# Modecleaner Suspension Design: Steel or Silica Fibres

Responses to questions raised by ribbon/fibre  
review committee

Presented to review team 17th January 2006

G060013-00-R

## Modecleaner Suspension Thermal Noise Estimate (quadratic sum of longitudinal and vertical\*)

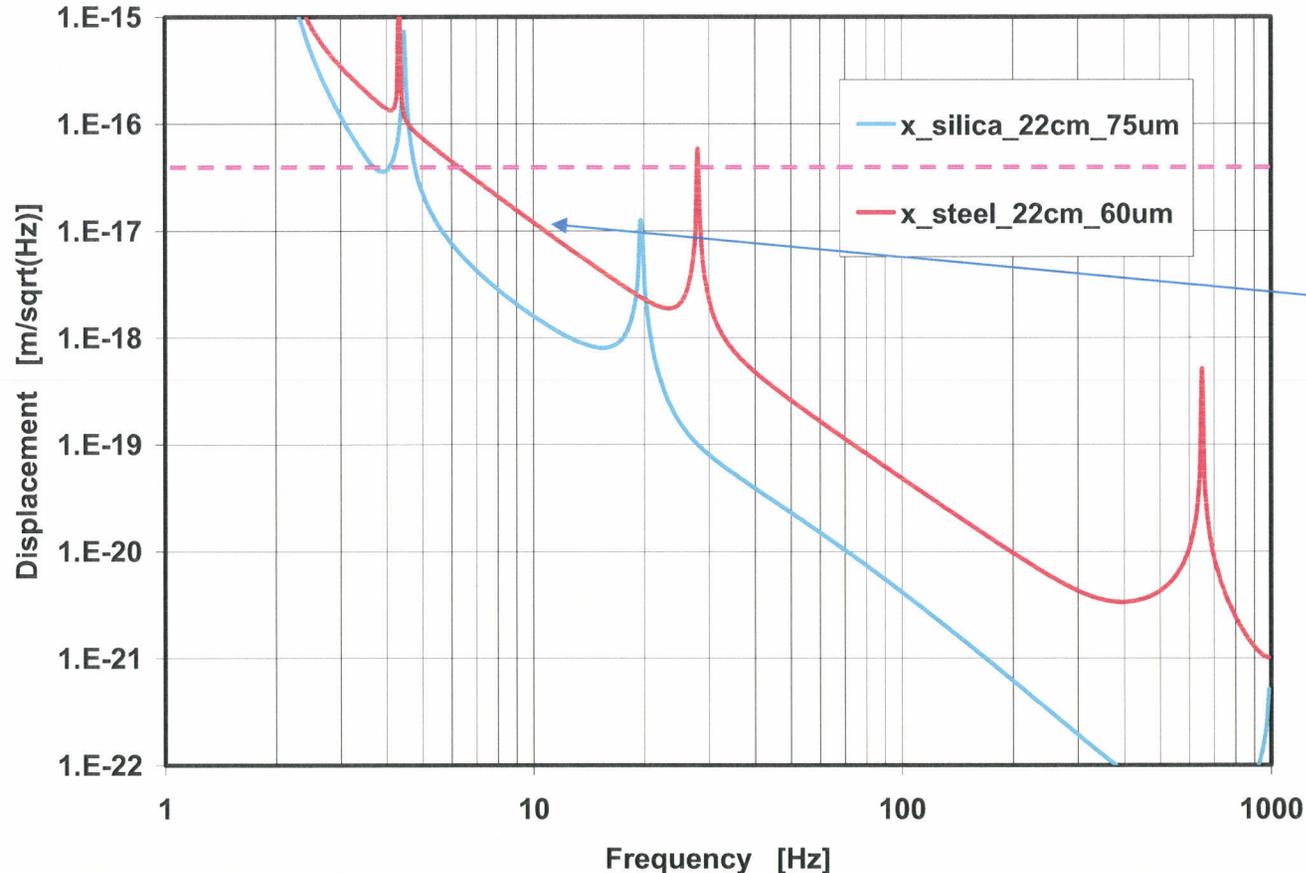
## 1) How much loss from friction between wire loops and the optic is being assumed for the MC suspension? Where does this come from? How well coupled are these plans and what we are learning from initial LIGO suspensions?

- We have considered both the case where there is no significant loss from friction, using an intrinsic material loss of  $2 \times 10^{-4}$ , and where the loss is assumed to be 10 times larger than this value, based on the findings with Initial LIGO

1.2 x 10<sup>-17</sup> m/√ Hz  
@ 10 Hz

If losses are 10 times larger, this value becomes √10 larger, still within current noise requirement

Blue: silica, material loss  $5 \times 10^{-7}$ , 75 micron radius, (stress 0.4 GPa).  
Red: steel, material loss  $2 \times 10^{-4}$ , 60 micron radius (stress 0.65 GPa)

Dotted magenta line = current noise requirement;  $4.2 \times 10^{-17}$  m/√ Hz @ 10 Hz (long + vert)
